# intel® Technical Advisory

TA-0767-1

## Intel® Server Compute Blade SBX82 May Lose Keyboard and Mouse Functionality in Pre-OS Environments

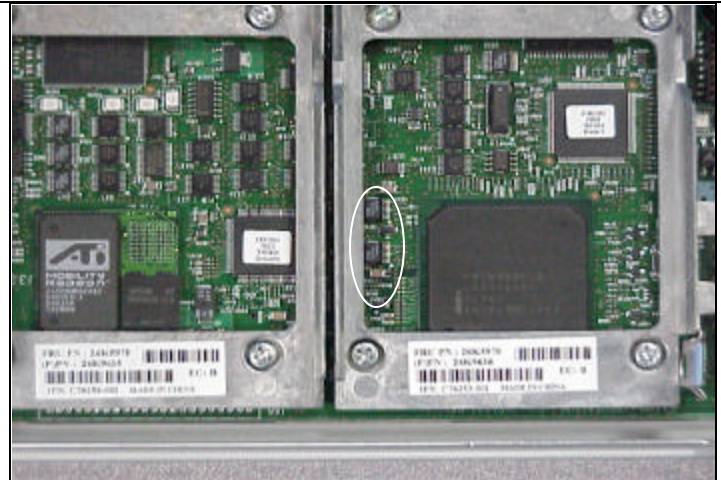
An unknown quantity of -001 Server Compute Blades SBX82 were built using a component on the board that may at times exert a level of capacitance that is beyond specification, causing an intermittent loss of the USB circuit that controls the keyboard and mouse in a pre-OS environment.

Component location is circled in the top two photographs. The photograph at the left shows the subject component part number: P13B 3257QE Y0418

This component will no longer be used in the production of the Server Compute Blade SBX82. An appropriate, functional substitute part has been identified, tested and will be used in all future builds.

Server Compute Blades SBX82 shipped after April 18, 2005 will not have the suspect part and will function appropriately. These blades can be identified by MM# 870607 and part number C76430-003.
